PLANNING COMMISSION AGENDA  
CITY OF PRAIRIE VILLAGE  
TUESDAY, JANUARY 5, 2016  
7700 MISSION ROAD  
7:00 P.M.

**TO:** Prairie Village Planning Commission  
**FROM:** Confluence, Kansas City, Kansas  
- Christopher Shires, AICP, Principal  
- PJ Novick, ASLA, LEED GA, Principal  
**DATE:** January 5, 2016, Planning Commission Meeting (Confluence Project # 15018KC)

**REQUEST:** Rezoning from CP-2 (Planned General Business District) to MXD (Mixed Use District), Approval of a Preliminary Development Plan, and approval of a Preliminary Plat and a Final Plat

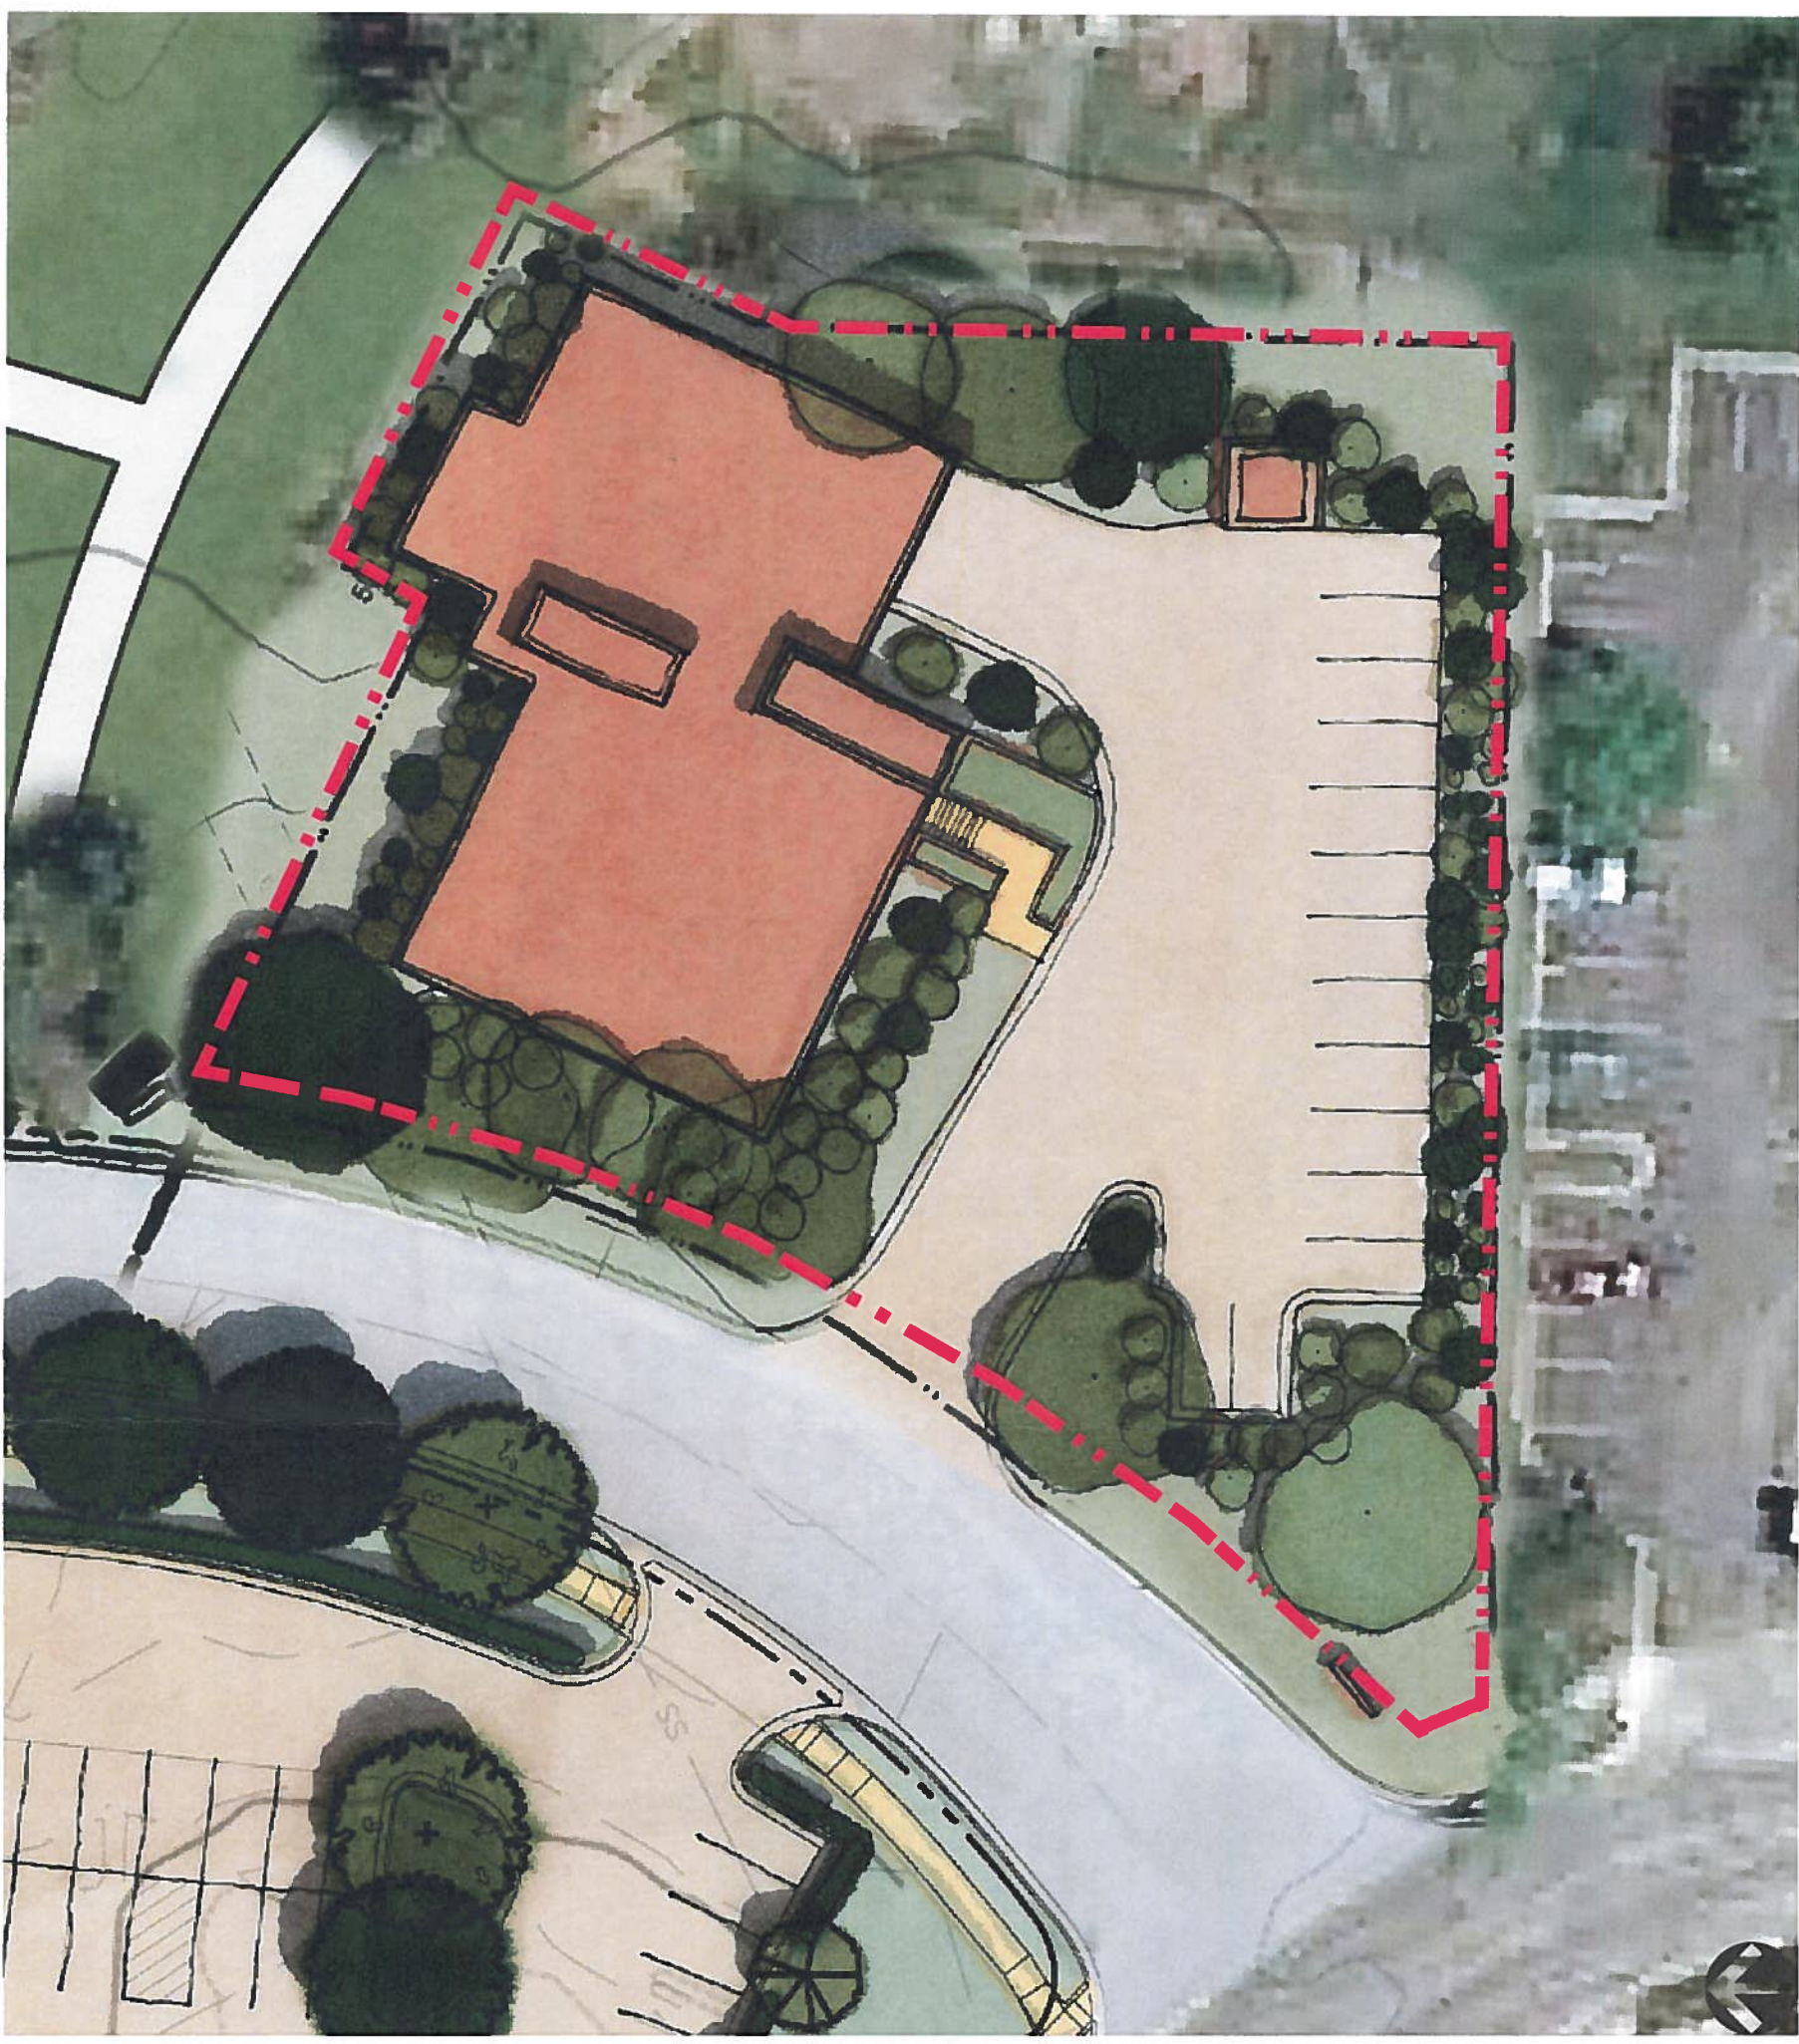
In general, staff feels that the structure would benefit from additional architectural relief along the east, west and south elevations; the large 'panels' of clear stained cedar appear somewhat stark and in sharp contrast to the surrounding structures. The applicant should consider additional articulation in this portion(s) of the façade. In addition, staff would recommend that the applicant provide images and additional information on the maintainability and the long-term appearance expected of the clear stained cedar siding. Staff also recommends that additional information be provided regarding the design, size, and materials of the diamond form on the south façade and define the locations of the use of stucco.

1. The applicant updating the architectural detail in the Vision Book Addendum to address staff's comments.
2. The applicant providing with the Final Development Plan, detailed plans for all trash enclosures and HVAC/building mechanical equipment screening to ensure that all trash dumpsters, recycling bins, HVAC and building mechanical equipment, etc., is fully screened from view. All screening shall be designed and constructed of materials that are durable and consistent and compatible with the building architecture.

# PRELIMINARY PLAT OF MEADOWBROOK 2020

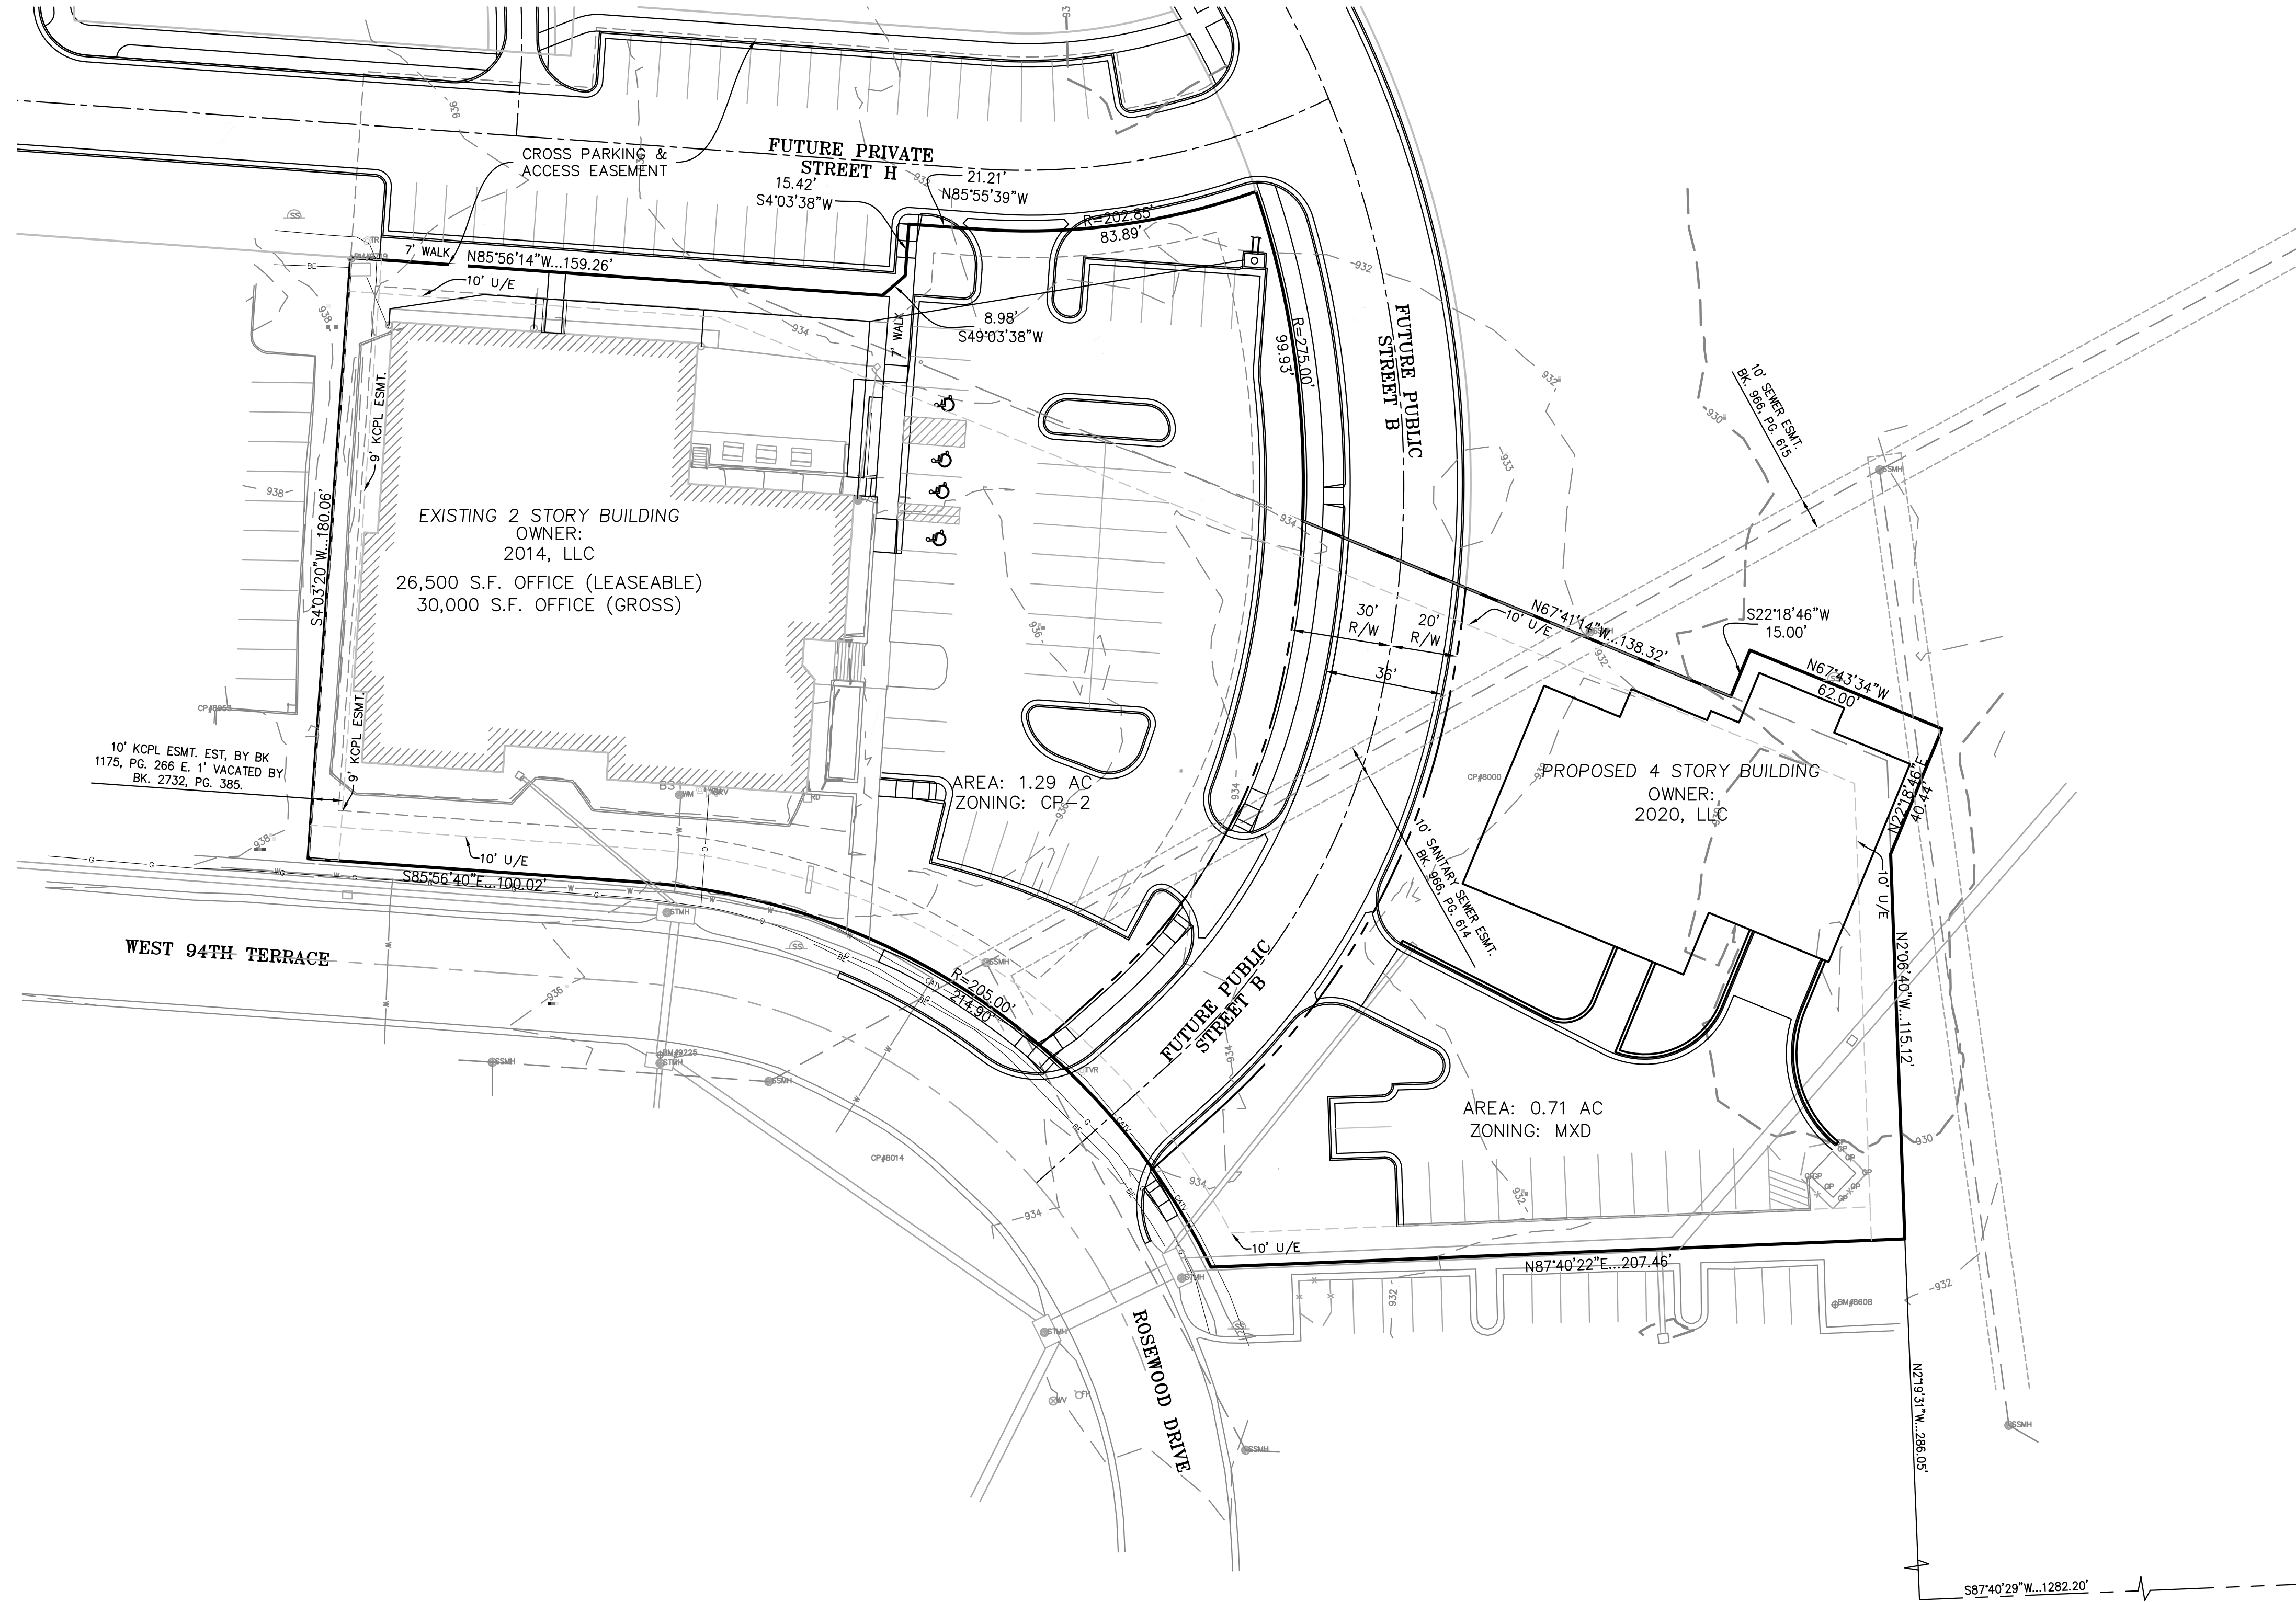
The Preliminary Plat should identify all existing and proposed easements, including those to be vacated, as well as the proposed building setbacks. The Preliminary Plat should clearly show the boundaries of the proposed lots, including the street lot, and label them. The Final Plat needs to define the boundaries of the proposed lots, including the street lot, and show and label the proposed building setback lines.
